COUNCIL ASSESSMENT REPORT

SYDNEY EASTERN CITY PLANNING PANEL

PANEL REFERENCE & DA NUMBER	PPSSEC-268 – DA/80/2023
PROPOSAL	Demolition of existing structures and construction of an 8 storey mixed use development with 3 basement levels comprising 56 units, retail and commercial tenancies, 90 car parking spaces, rooftop communal open space, and strata subdivision. (Integrated Development: Concurrence required from Water NSW).
ADDRESS	Lot 1 in DP506844 and Lot 2 in DP506844 138 Maroubra Road, Maroubra
APPLICANT	Mr Leigh Manser, Maroubra Property Developments Pty Ltd
OWNER	Bonrill Pty Ltd
DA LODGEMENT DATE	10 March 2023
APPLICATION TYPE	Development Application
REGIONALLY SIGNIFICANT CRITERIA	Clause 2, Schedule 6 of <i>State Environmental Planning Policy (Planning Systems) 2021</i> : Development that has a capital investment value of more than \$30 million.
CIV	\$44,330,000 (including GST)
CLAUSE 4.6 REQUESTS	Clause 4.3 Height of Building
KEY SEPP/LEP	Transport and Infrastructure SEPP Biodiversity and Conservation SEPP Resilience and Hazards SEPP Randwick LEP Housing SEPP & ADG

Figure 7: Height Plane Analysis (Drawing DA8.320, DJRD Architects)

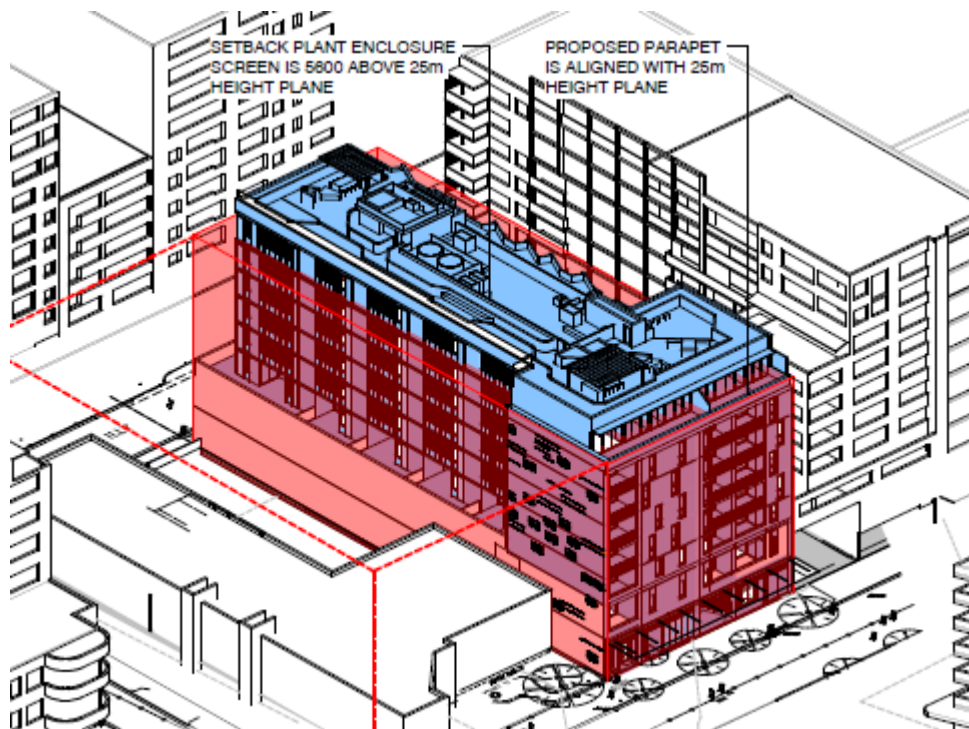
Pursuant to Clause 4.3 of RLEP 2012, a maximum height of 25.0m is applicable to the subject site. The proposal seeks a maximum overall building height of 31.75m (6.25m or 27% variation). The section drawings indicate a maximum RL to the top of the lift overrun of RL56.5m and an existing ground level of RL24.75. Additionally, the following elevation and massing diagram shows the height exceedance (25m height is in red).

Figure 10: Maroubra Junction Centre – Block 6 Building Envelope Plan

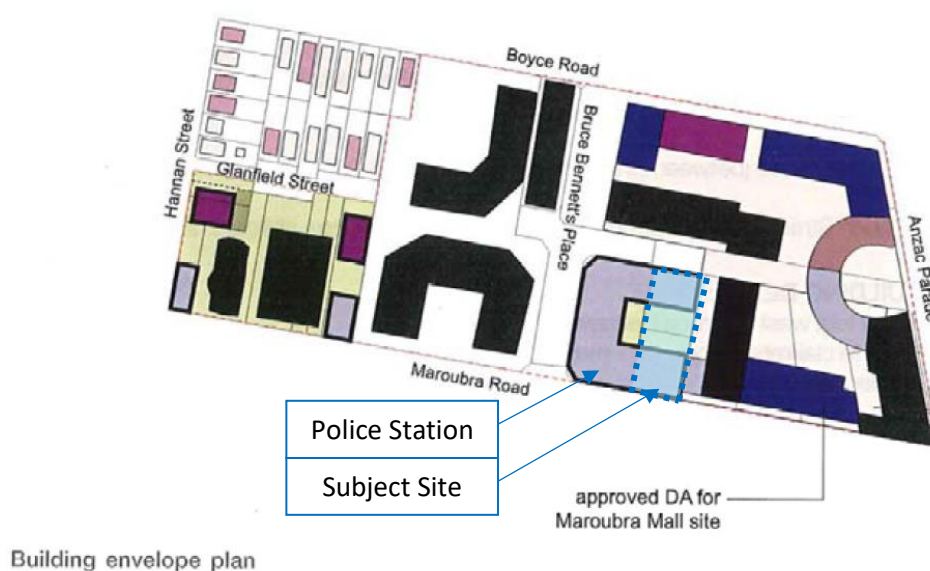
The anticipated building envelope for the site is illustrated in Figures 9 and 10. The desired envelope across 136 and 138 Maroubra Road is typically referred to a "C"-shaped, with 138 Maroubra Road (the subject site) envisioned to provide most of the central open space (also referred to as the 'courtyard' or 'atrium') and two primary towers of shop-top housing. The proposed development has significantly deviated from the "C"-shape, and proposes a "T"-shape that extends through the entire length of the lot, without the break in the built form.

Figure 11: Maroubra Junction Centre - Height (subject site outlined and highlighted in blue)

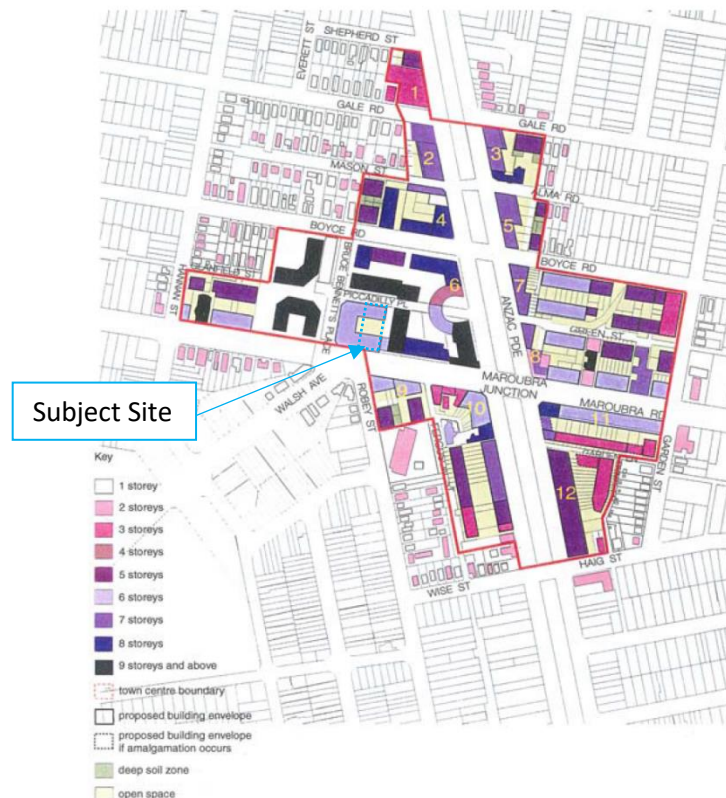
The site is subject to a six (6) storey building height (Figure 11). The proposed development exceeds this standard by two (2) storeys, with a proposed development of eight (8) storeys inclusive of one residential level and rooftop communal open space (partial 9th storey). Additionally, the centre of the site is identified as a future 'open space'. This is further discussed below with respect to the Block 6 objectives and controls.

Figure 12: Excerpt of ‘DCP Envelope Analysis Sheet 2’ (Drawing DA0.150 by DJRD Architects)

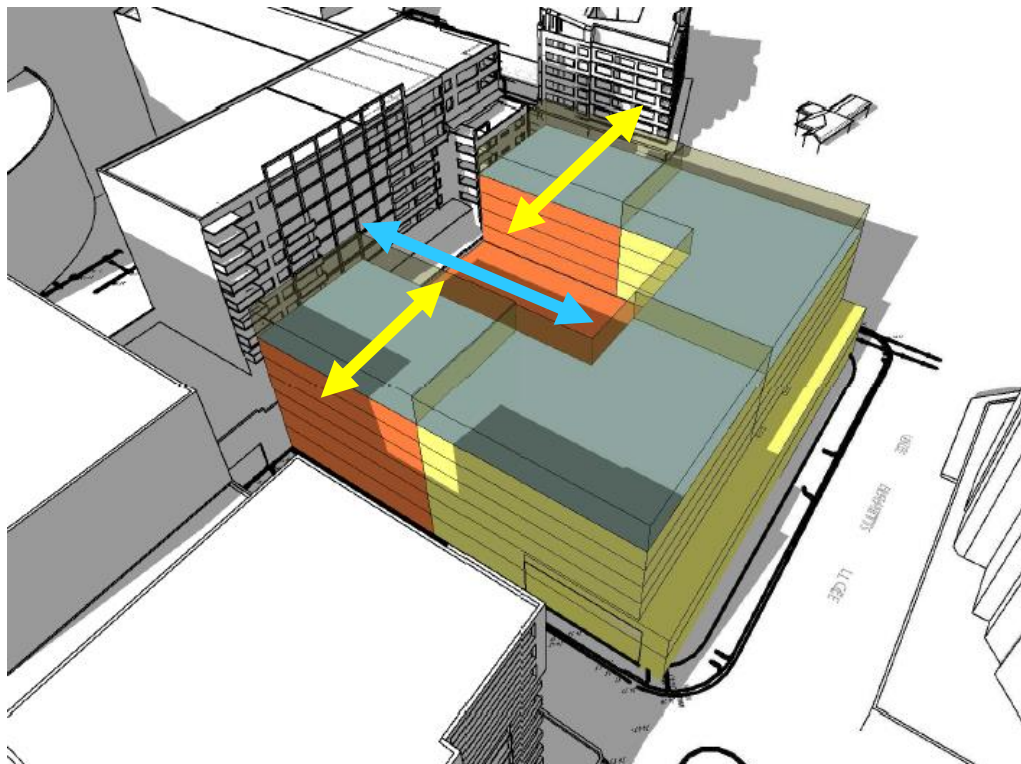
As demonstrated in Figure 12, compliance with the building depth and building envelope controls offers opportunities for two towers with dual-aspect apartments [*indicated with yellow arrows*] as well as a central courtyard/open space that provides visual relief and passive sunlight and ventilation through the centre between Pacific Square and 136 Maroubra Road (Police Station) [*indicated with blue arrow*].

Concluding Comment: There are insufficient grounds for justification in varying the DCP Building Envelope, and the building depth proposed should not be supported.

Figure 13: Notated excerpt of ‘Police Station – Potential Development Study’ (Drawing DA0.151 by DJRD Architects)

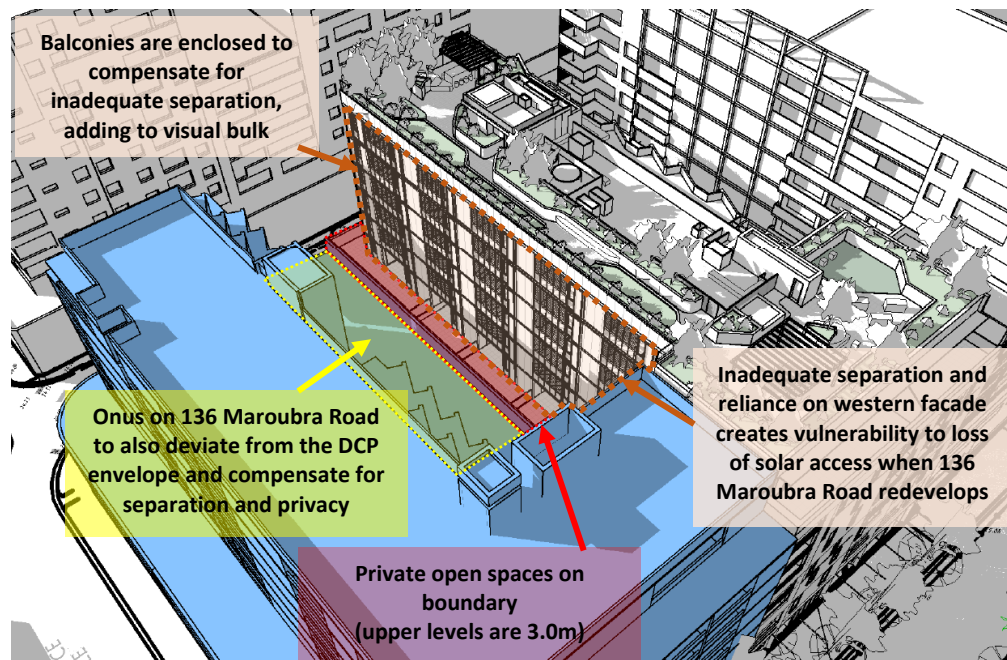
- Levels 2 extends the principal private open spaces for 6 (six) units to the western elevation, placing the onus on future development of 136 Maroubra Road (Police Station) to implement additional separation or privacy measures. Refer to Figure 13.
- Residential Levels 3 through to Level 7 are proposed with a 3.0m setback from the western elevation, a shortfall from the 6m to 9m otherwise required. The inadequate setback further burdens future development at 136 Maroubra Road (Police Station) and has implications on the solar access received by the proposed development when 136 Maroubra Road is redeveloped (particularly if it were to align with the built form suggested for 136 by the Applicant – Figure 13).

- ***Poor Amenity Outcomes (Separation, Privacy, Solar Amenity)*** – Residential Levels 3 through to Level 7 are proposed with a 3.0m setback from the western elevation, a shortfall from the 6 to 9m otherwise required (Figure 13). The inadequate setback further burdens future development at 136 Maroubra Road (Police Station) and has implications on the solar access received by the proposed development when 136 Maroubra Road is redeveloped (particularly if it were to align with the built form suggested for 136 by the Applicant). Inadequate information was provided to ascertain what the impact of the indicative redevelopment of 136 Maroubra Road would have on the solar amenity of the proposed development (as amended). Coupled with the enclosed balconies to the majority of apartments that rely on the western elevation for solar amenity, there is a poor solar amenity outcome as result of deviating from the DCP Building Envelope.

Figure 18: Excerpt of 'DCP Envelope Analysis Sheet 2' (Drawing DA0.150 by DJRD Architects) [Copy of Fig. 12]

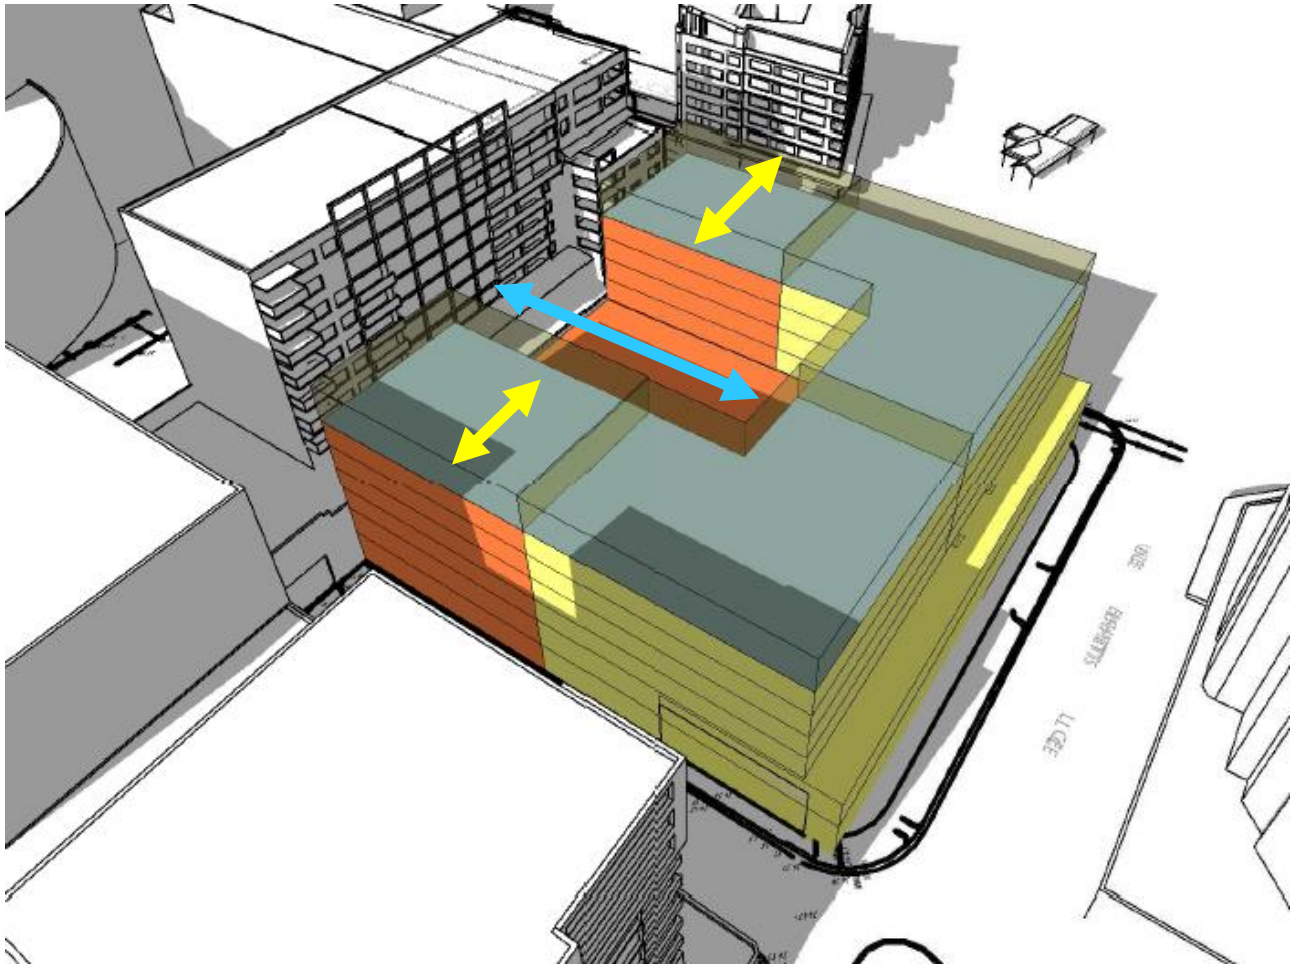
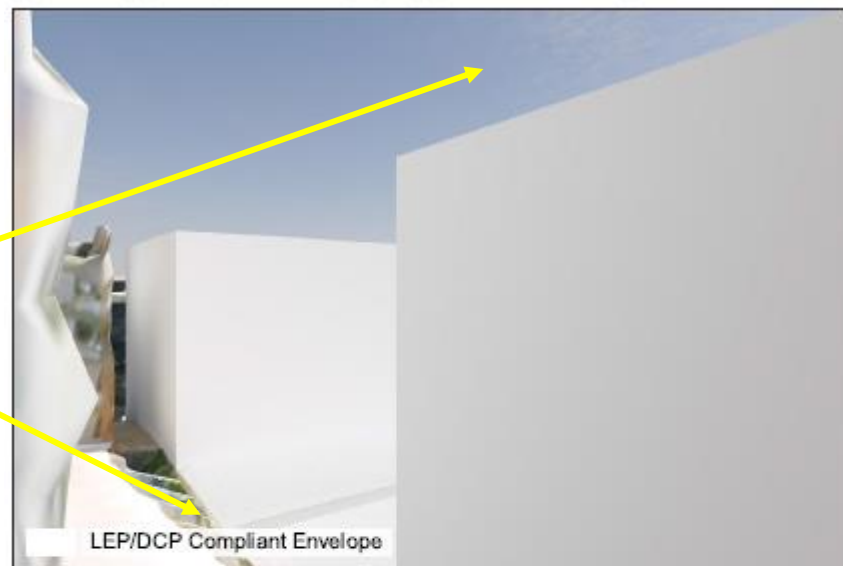
- Improved communal open space and landscaped outcome are achieved through the incorporation of the central open space. As demonstrated in Figure 18 [a copy of previous Figure 12], compliance with the building depth and building envelope controls offers opportunities for two towers with dual-aspect apartments [indicated with yellow arrows] as well as a central courtyard/open space that provides mutual visual relief (that presents the opportunity to be landscaped) and passive sunlight and ventilation through the centre between Pacific Square and 136 Maroubra Road (Police Station) [indicated with blue arrow].

- This is further illustrated when comparing a DCP ‘compliant’ envelope and the proposed development; renders of which were provided within the View Impact Renderings and Methodology Report (Figure 19).

- It is considered that the proposed footprint and siting of the proposed building has not been oriented to maximise privacy between adjacent buildings (Figure 14) given that the "C"-shape building envelope offers the opportunity for two building towers that could accommodate north-south dual-aspect residential units (Figure 18).

- The DCP "C"-shape building envelope provides opportunities to provide north-west dual aspect residential apartments to both towers that do not result in direct overlooking (Figure 18).

- It is reiterated that a DCP compliant building form (Figure 18 and 19) offer improved shared amenity through Block 6.
- The proposed development has not thoroughly considered its siting and context, being adjacent to a Police Station to the west, and a child care centre to the east, resulting in unresolved acoustic impacts and inadequate separation from existing land uses.

There is a benefit demonstrated (Figure 19) that the anticipated massing, which has not been delivered by the proposed development, improves visual relief and outlook for residents of the eastern Pacific Square development.

Figure 20: Excerpt of 2pm sun-eye diagrams (DA8.324 (left) and DA8.327 (right))

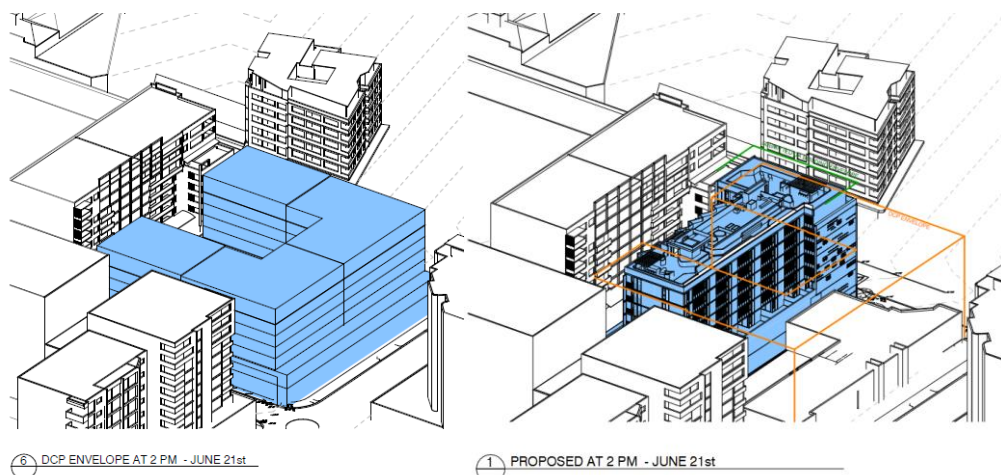
- The sun-eye diagrams compare a 7-storey "C"-shape building envelope to the proposed development (as amended) – this is not a true representation of comparing a DCP-compliant envelope (6-storeys) to the proposed development (Figure 20), and it could be surmised that the impact of a DCP compliant development would provide additional direct sunlight to the units of Pacific Square, however, it is acknowledged that the LEP building height of 25.0m would permit a 7-storey form.

- Hourly shadow diagrams were requested and have not been submitted for assessment. It is therefore unclear what the extent of the comparative overshadowing impact is between a DCP compliant envelope, and the proposed development. The application only provides information for 2pm (Figure 21) – thus the applicant's justification cannot be confirmed.

Figure 21: Excerpt of 2pm shadow diagram (DA8.321)

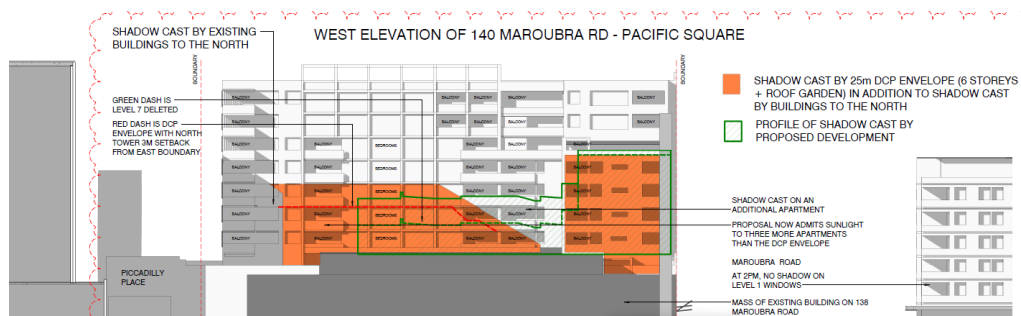
- As detailed in Figure 18, there is a clear benefit to the delivery of the “C”-shape building envelope, including:
 - Shared passive sunlight;
 - Shared passive ventilation;
 - Shared building separation offering privacy (both acoustic and visual);
 - Shared visual relief through the centre.

- No planning concern is raised with respect to overshadowing toward Maroubra Road/public domain, 165-167 Maroubra Road or 2 Robey Street.
- In view of Figure 18 and Figure 20, the anticipated DCP Envelope, being the two residential towers, would benefit from the northern aspect to two façades

Figure 23: Excerpts from Page 90 (View from RL49.72; left) and Page 100 (View from RL55.81) of the View Impact Renderings – demonstrating excessive visual bulk as a result of deviating from a compliant building envelope.

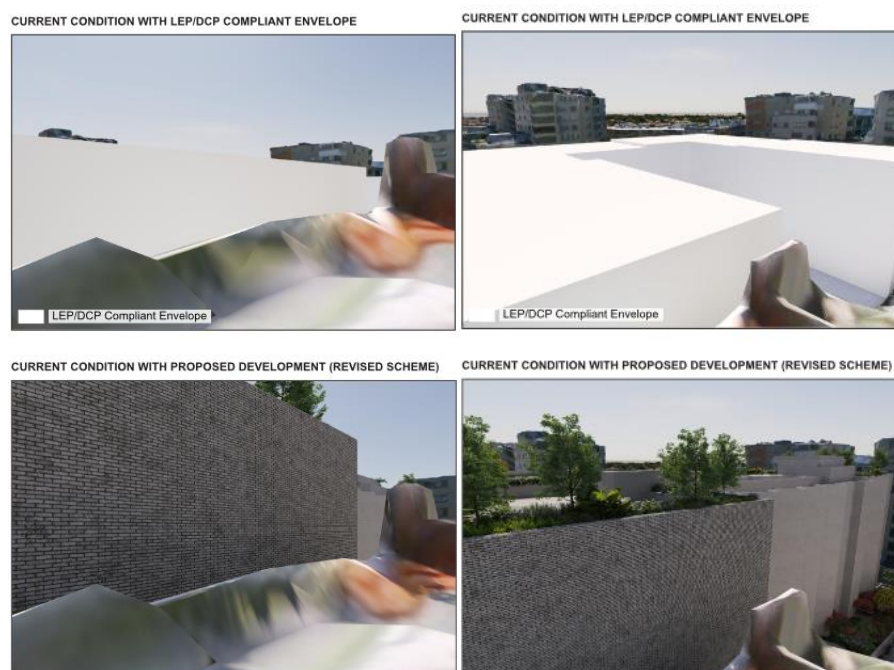
- The submitted view analysis concludes in nearly all cases, that "....A DCP compliant envelope would maintain a long term view". This is concurred.
- An assessment of the submitted View Impact Renderings and Methodology Report illustrates the loss of outlook and water (horizon) views from the existing development to the east ("Pacific Square") as a result of exceeding the height and storeys controls (Figure 22).

- A compliant building height would be at approximately RL50.00. Pacific Square units at around this level and above are negatively affected by the additional bulk proposed by the development (Figure 22), with horizon water views completely removed.

- As previously addressed, the amalgamation of the sites is not necessary to facilitate the outcomes anticipated by the DCP "C"-Shape Building Envelope. The central open space provides passive sunlight and visual relief through the break in the built form (as evident in Figure 22).

- The renders provided also clearly show large extents of unarticulated blank walls that the existing south-western units will have an outlook to, compared to an LEP/DCP compliant scheme (Figure 23), demonstrating the proposed height and envelope variation results in excessive visual bulk.
